City of Hollywood Planning Division 2600 Hollywood Boulevard Hollywood, FL 33020

Based on your Preliminary TAC Review comments dated February 20th, 2018 Keith and Associates (K&A) offers the following responses to your comments/questions:

6 – Final TAC Comment Responses

g name: N:10110067.00 - Prinnacle at Peacefield - PHG:Engineering/Cadd/10067.00 SP-101 Site Plan.dwg Layout Name: SP-101 Plotted by: dkoggan Plotted on: Mar 02, 2018 - 3:53pm

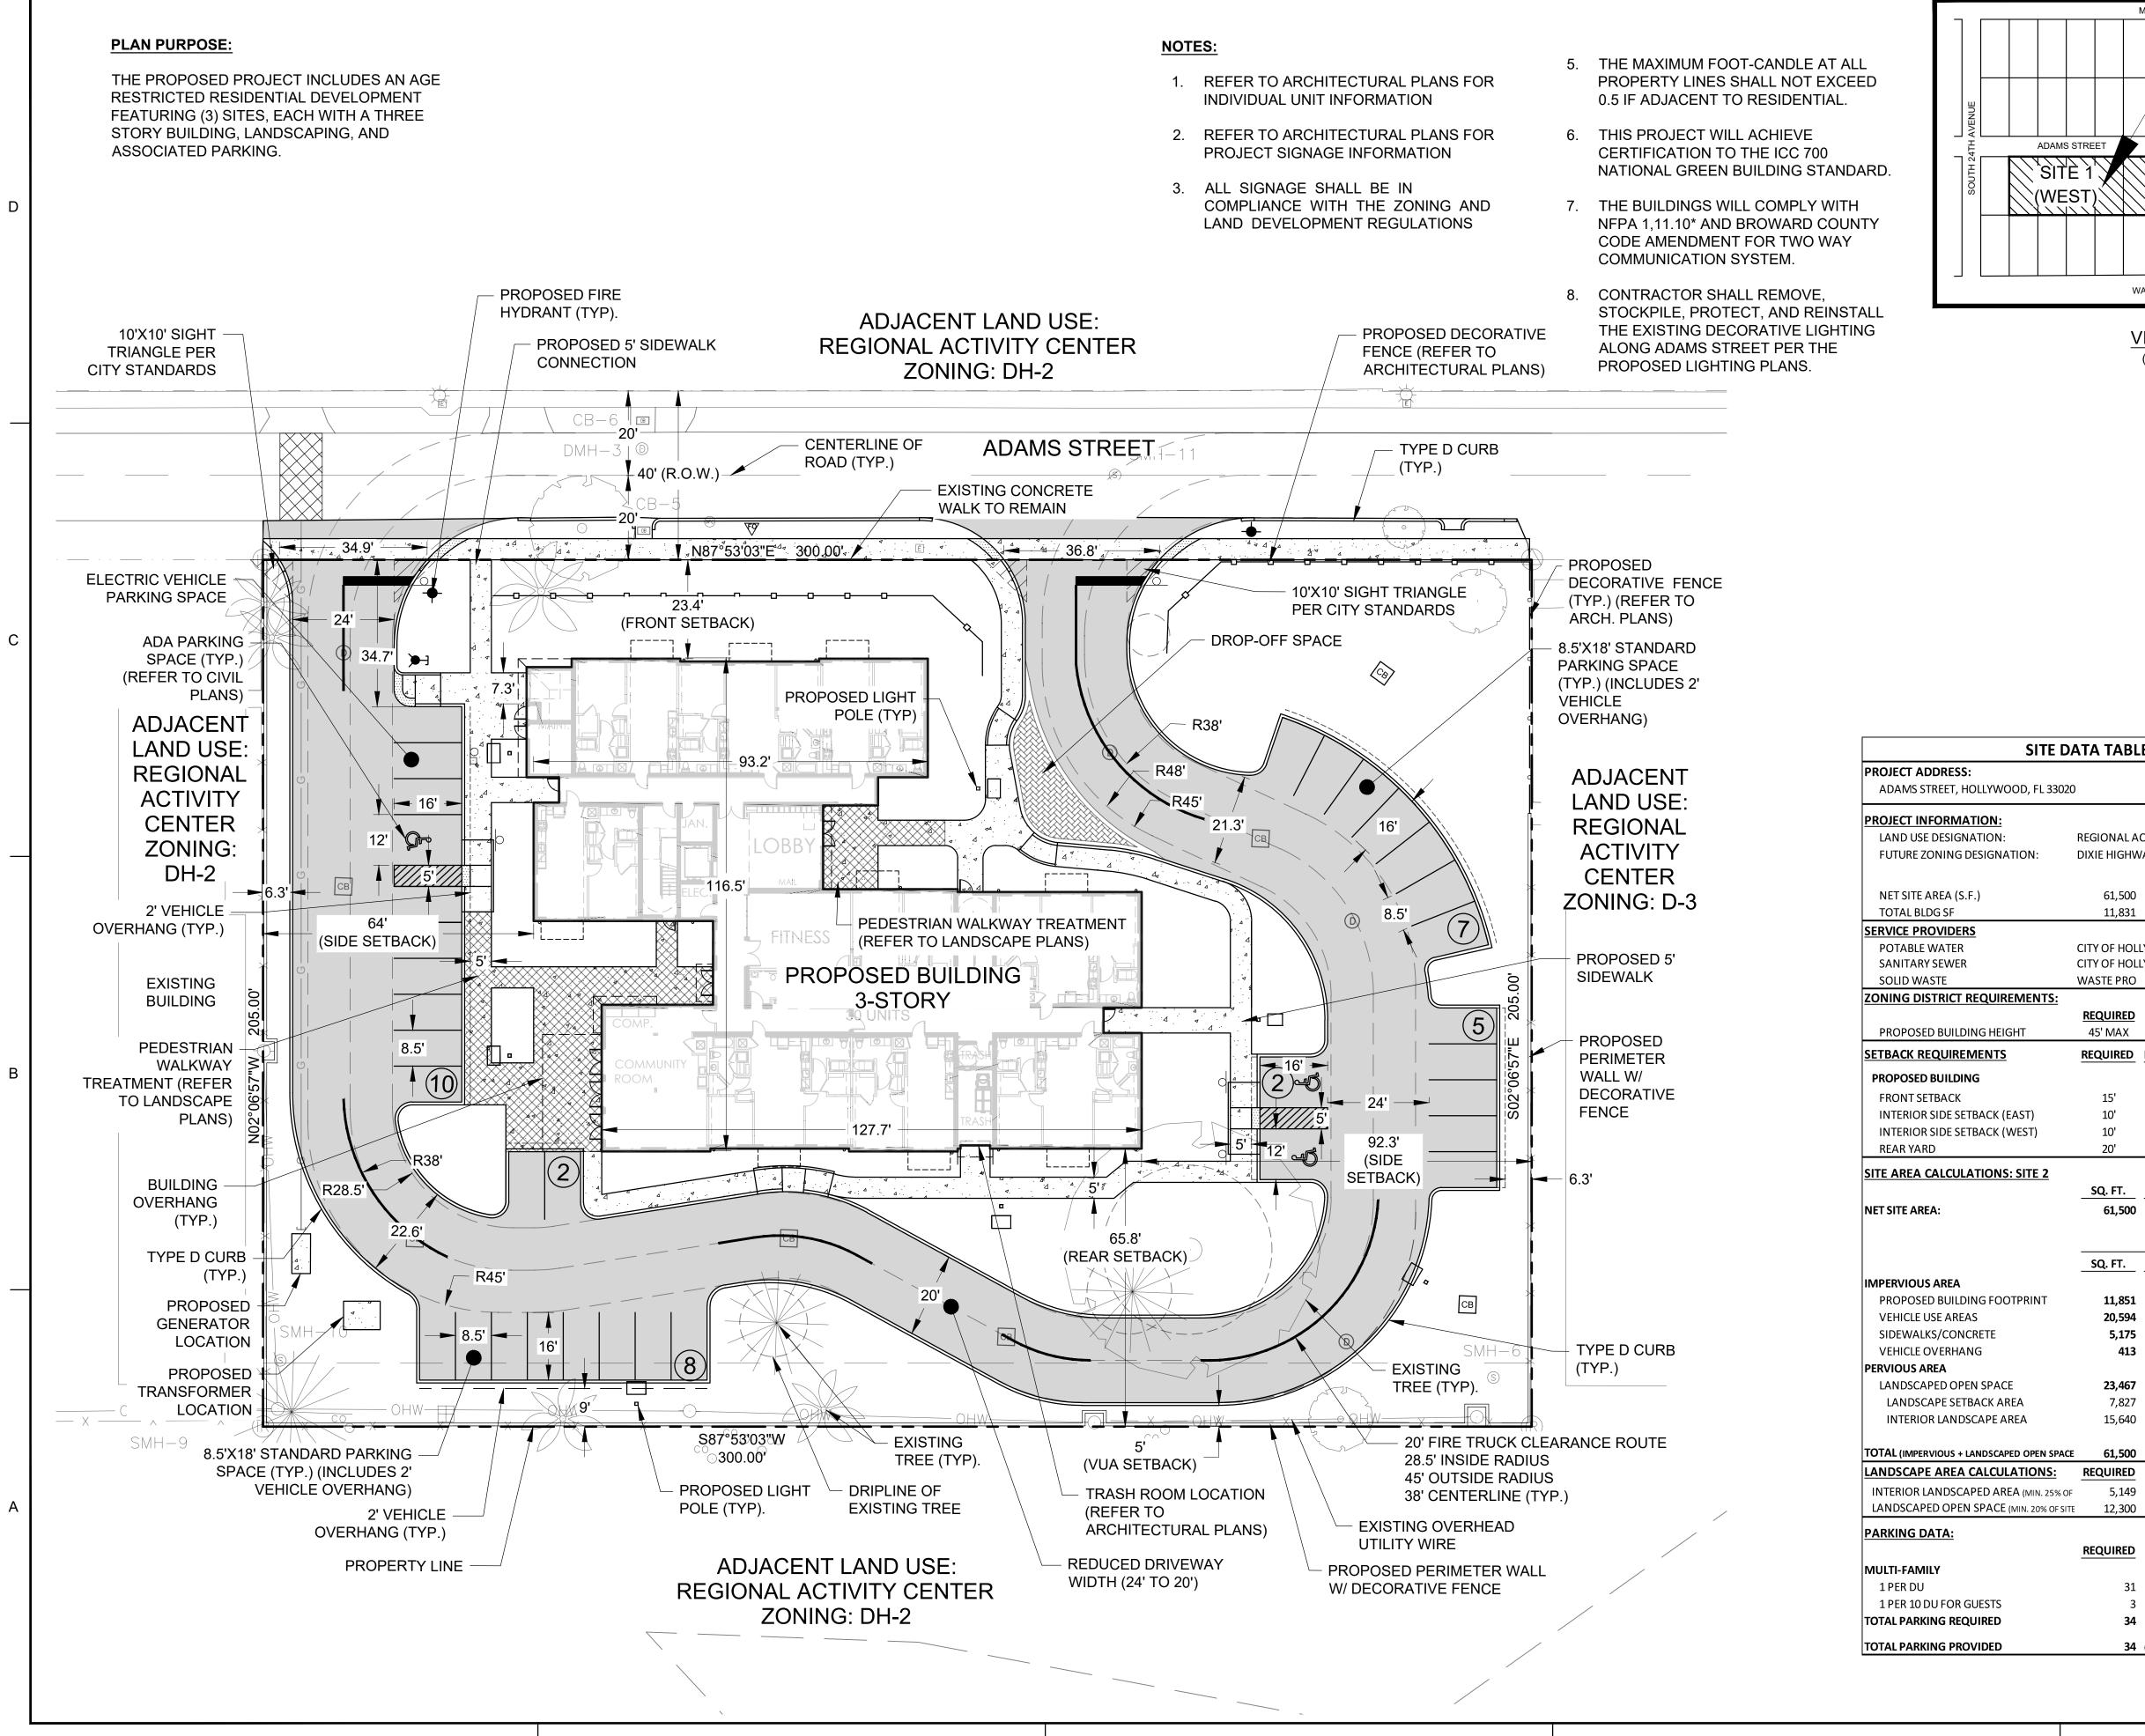
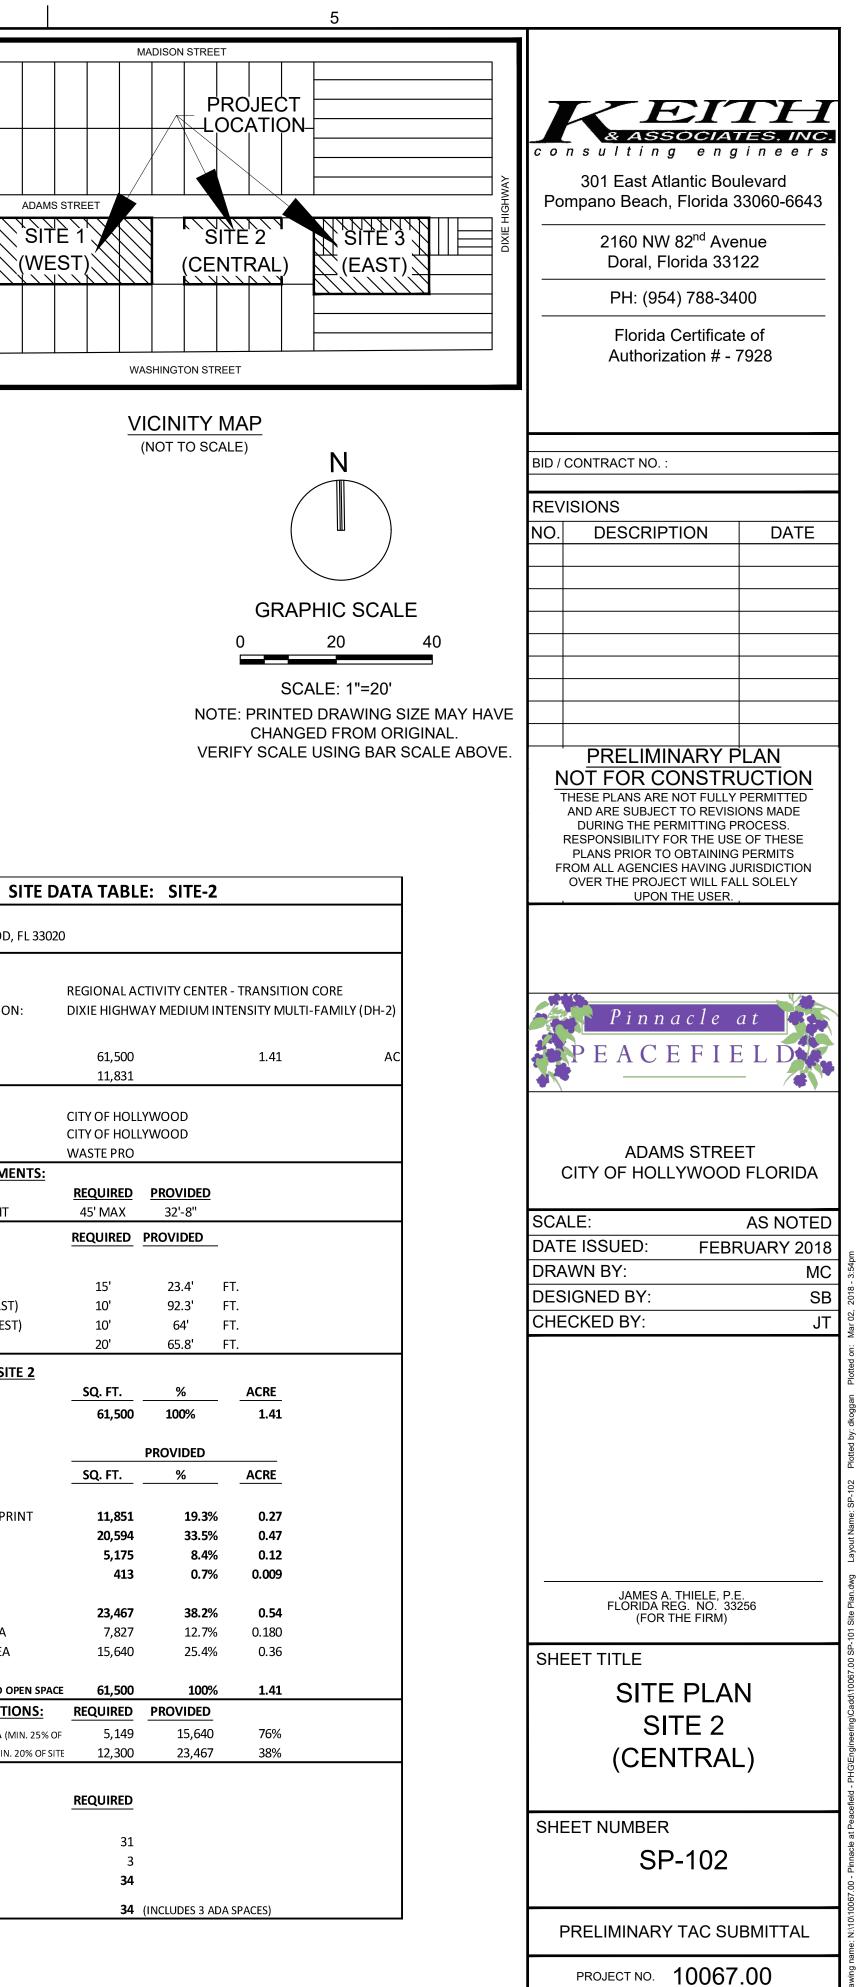
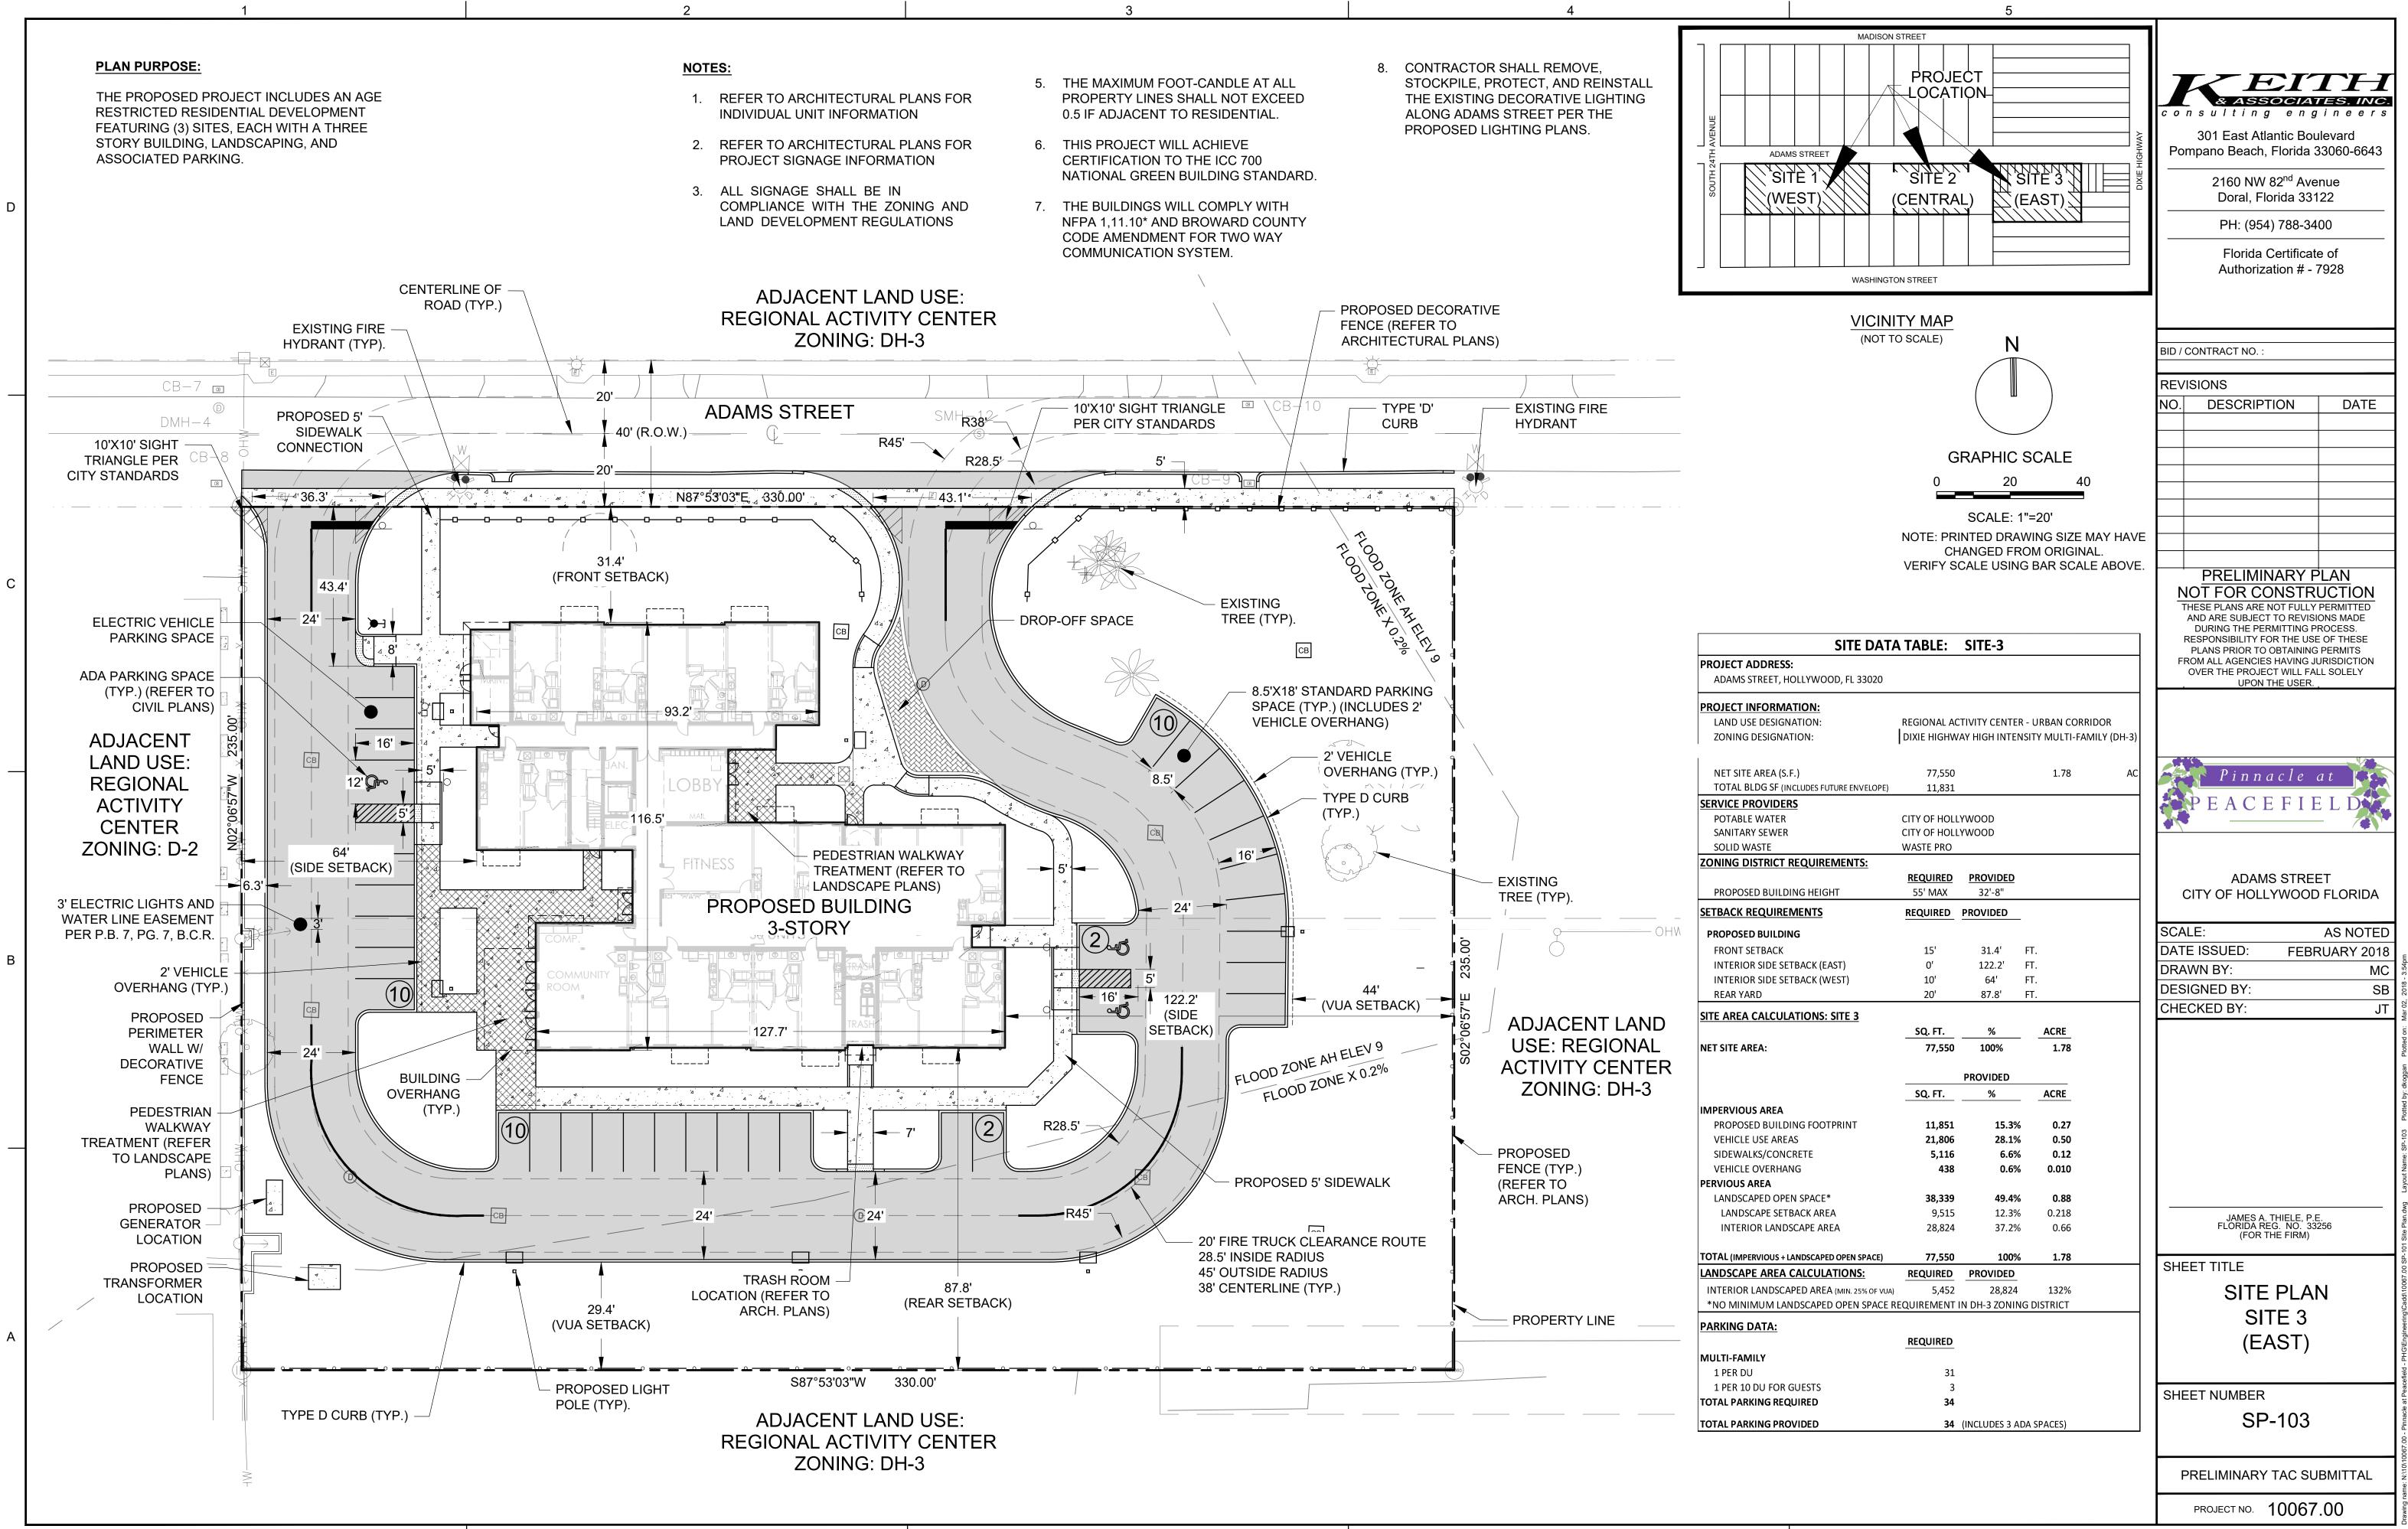
- Project is required to install electric vehicle charging station infrastructure, please see Ordinance O-2016- 02.
 RESPONSE: We have added one electric vehicle charging station on each site. Refer to site plan sheets SP-101 to SP-103 for locations.
- 2. The driveway minimum is 22'. Revise accordingly in Site 2 Site Plan.

Include note on Site Plan stating the maximum foot-candle level at all property lines (maximum 0.5 if adjacent to residential).
 RESPONSE: A note has been added to the site plan (SP-101 - SP-103) and the photo metric plan demonstrates the lighting level foot candles at the property line which do not exceed the maximum foot candles per the code.

RESPONSE: We have indicated a narrowing of the drive isle in the rear of the building on Site 2 from 22' to 20' for an approximately 125' length, which does not abut any parking spaces, in order to save 2 specimenquality Slash Pines and 1 Live Oak tree with a significant canopy. These trees are deemed to be in very good condition and the value in saving them (Slash Pines generally do not survive transplant) we believe greatly exceeds the value of complying with the minimum driveway width. We respectfully request the City grant an administrative waiver to provide for the narrower driveway width. We also believe that the narrow driveway width, combined with the serpentine manner in which the roadway is curved to preserve the tree canopy, will offer aesthetic and practical benefits, such as traffic calming.
